ERRATA for
PE Civil: Water Resources and Environmental Practice Exam
ISBN: 978-1-947801-33-2
Copyright 2023
Errata posted 01/06/2025

Revisions are shown in red.

Question 21, p. 13:

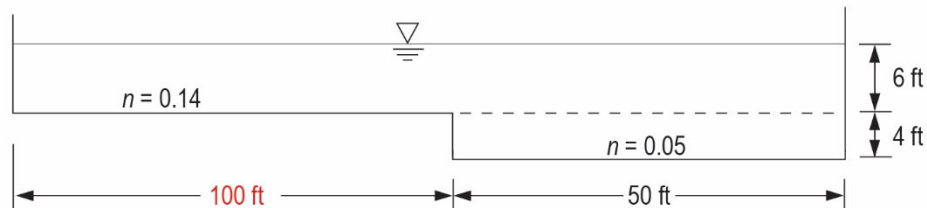
A western community uses a water treatment facility to treat raw well water for iron and manganese removal. The water plant is no longer allowed to direct discharge backwash waste to the local receiving stream. The facility has **four, 12-ft square** gravity filters. A new red water lagoon is proposed to contain all backwash waste. Assume the average backwash rate is 15 gpm/ft² and the facility backwashes each filter in a single day once per week for 25 min. each. According to TSS Water Works 2018, the minimum lagoon size (ft) required is most nearly:
